Coral Bay Boating Facility

Department for Planning and Infrastructure

**Report and recommendations
of the Environmental Protection Authority**

**Environmental Protection Authority
Perth, Western Australia
Bulletin 1107
August 2003**

Figure 2: Site plan of North Bills Bay proposal.

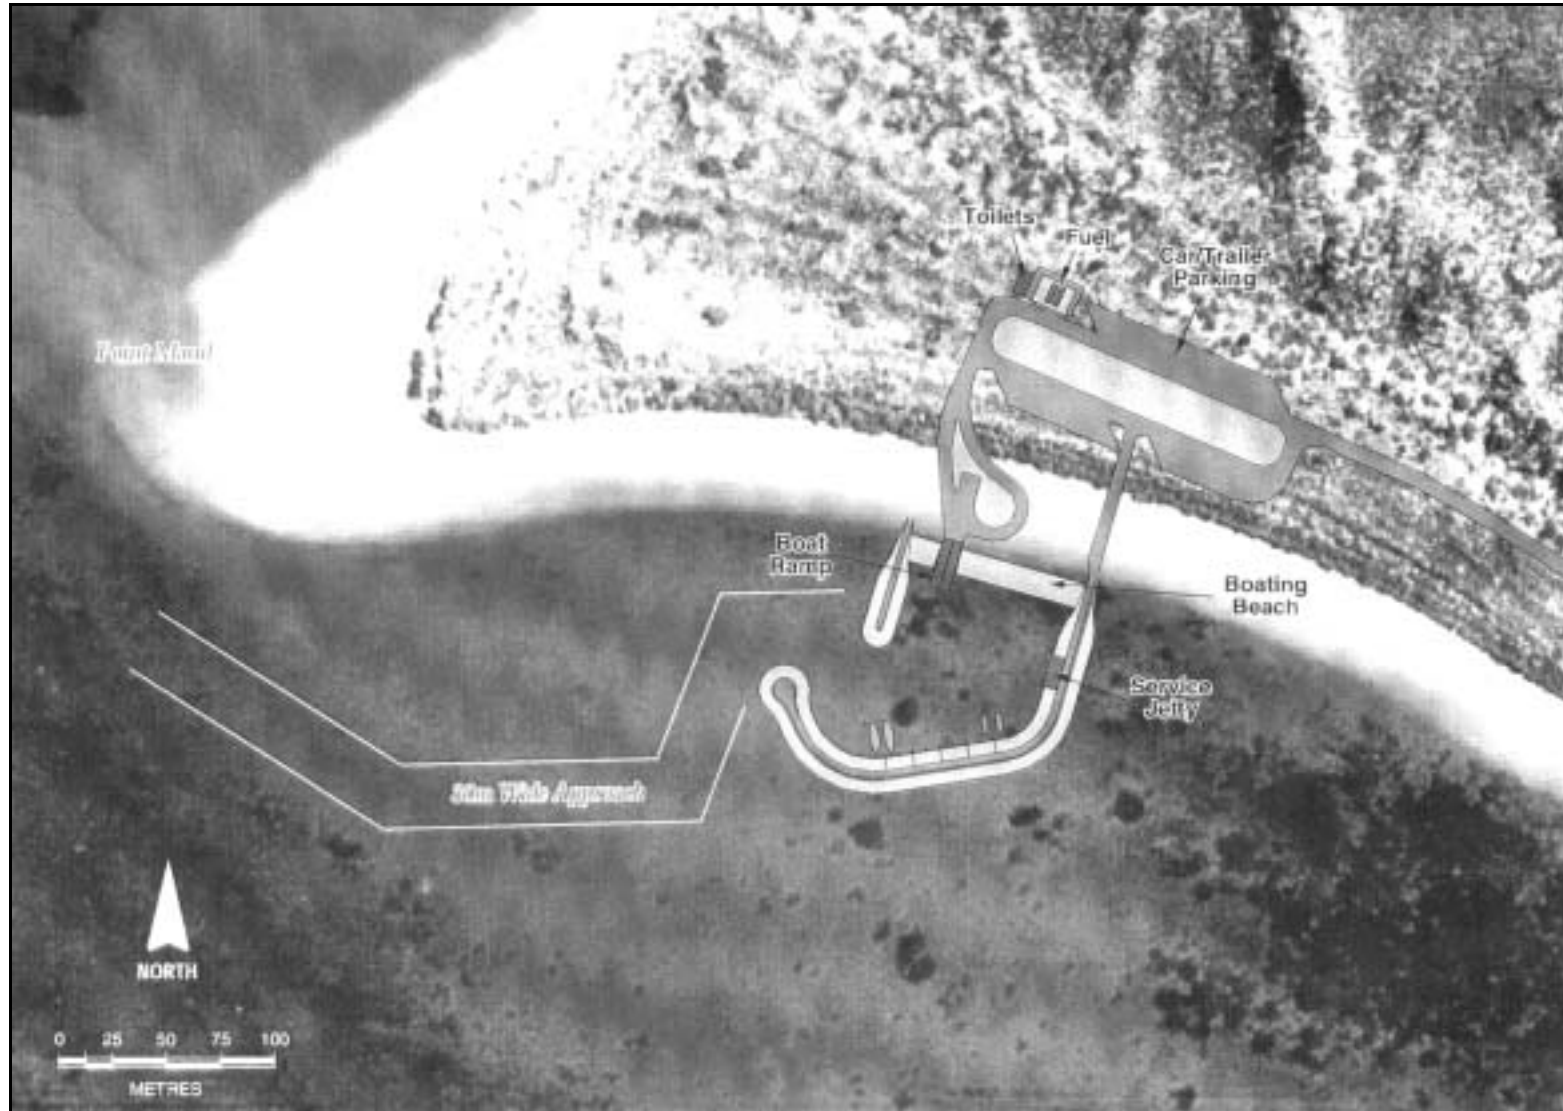
Taking this into account, the EPA considers that the proposal to construct and operate a boating facility at North Bills Bay, as proposed, is environmentally unacceptable as it cannot be managed to meet the EPA's objectives in relation to marine biodiversity, terrestrial biodiversity and coastal processes.

The North Bills Bay proposal (Figure 2) involves the development of a breakwater to provide shelter from prevailing waves for a boat ramp, service jetty and mooring pens. Effectively this breakwater would provide for the development of a small enclosed boat harbour. The overall facility would involve the development of an access road, car park, public toilets, boat fueling facilities and some public lighting. The proposed development site is located immediately to the south of Point Maud and is within the Maud Sanctuary Zone of the Ningaloo Marine Park.

As has been discussed, the Ningaloo Marine Park Management Plan specifically states a prescription that “groynes, breakwaters or similar constructions not be constructed in the Sanctuary Zone”. The potential for such a construction to cause direct and long term impacts in an area of such environmental significance needs to be recognised. The potential management proposed for the control of impacts on coastal processes is not of sufficient surety to ensure that significant impacts do not occur.

Figure 3: *Site plan of the Monck Head proposal*

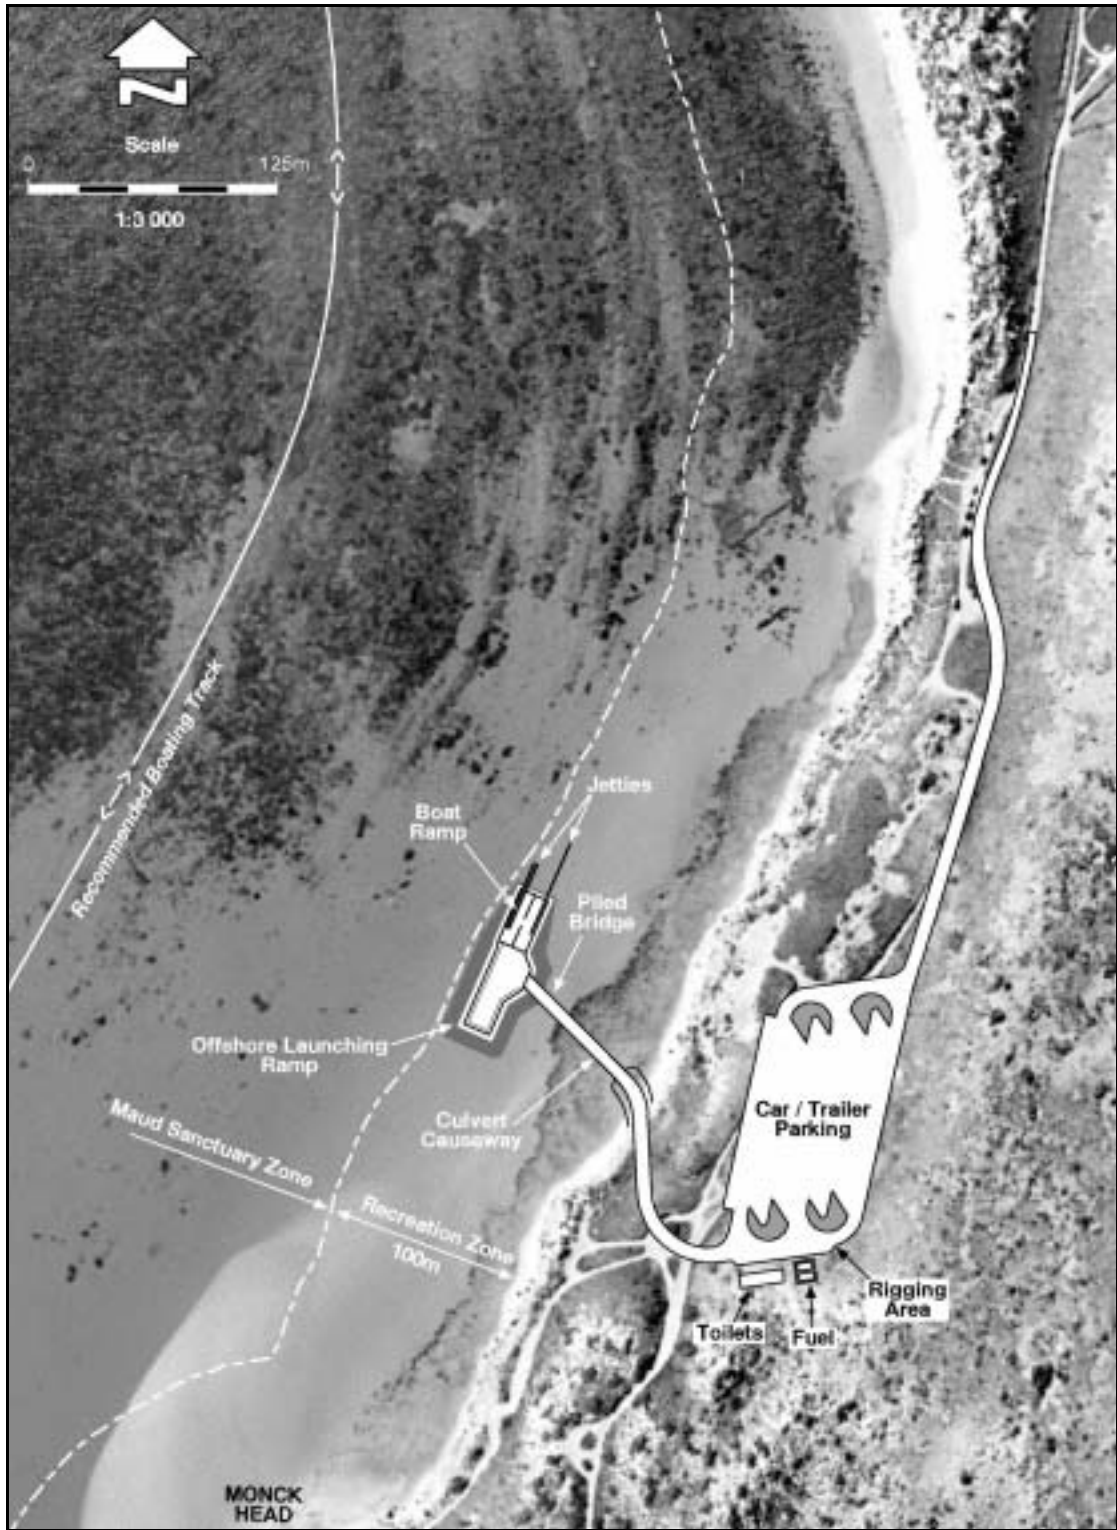
In relation to the Monck Head proposal, the EPA notes that the proposed development area is within the Recreation Zone of the Ningaloo Marine Park. The Ningaloo Marine Park Management Plan does not recommend against the development of the infrastructure associated with a boating facility in this Zone. The location of the Monck Head proposal is such that its footprint is unlikely to impact on the values of the Ningaloo Marine Park. While there will be some impact on macroalgal communities, there will be no direct impact on corals. The Monck Head site is within an area of stable hard coast. Considering this, and the design of the facility, incorporating a piled bridge and culvert causeway, impact on the coastal processes of the area is unlikely. However, the construction of the facility will have to be carefully managed to ensure that there is no indirect impact on the adjacent Sanctuary Zone of the Ningaloo Marine Park.

The EPA has recommended a condition which provides for the management of turbidity from construction and maintenance of the facility, particularly in relation to use of a silt curtain and the establishment of criteria to limit the potential for a significant decline in background water quality in the area. In addition, while it is expected that the proponent shall not cause or allow the discharge of hydrocarbons into the Ningaloo Marine Park, the EPA considers it important that the proponent have in place a Pollution Contingency Management Plan. As such, for the Monck Head proposal, the EPA has concluded that it is unlikely that the EPA's objectives would be compromised provided there is satisfactory implementation by the proponent of the proponent's commitments and the recommended conditions set out in Appendix 5 and summarised in Section 4.4.

The Monck Head proposal (Figure 3) involves the development of an offshore boat launching ramp with a piled bridge and culvert causeway connecting the offshore boat ramp to the shoreline. The proposal also provides for offshore moorings, access road, car park and refuelling facilities. As a piled bridge and culvert causeway would be connecting the offshore boat ramp to the shoreline, interruption of longshore drift would be minimised. Dredging would not be required during construction and only a small level of sand bypassing through excavation work would be required during operation. The Monck Head proposal is located within the Recreation Zone of the Ningaloo Marine Park, however, the offshore boat launching ramp is adjacent to the Maud Sanctuary Zone.
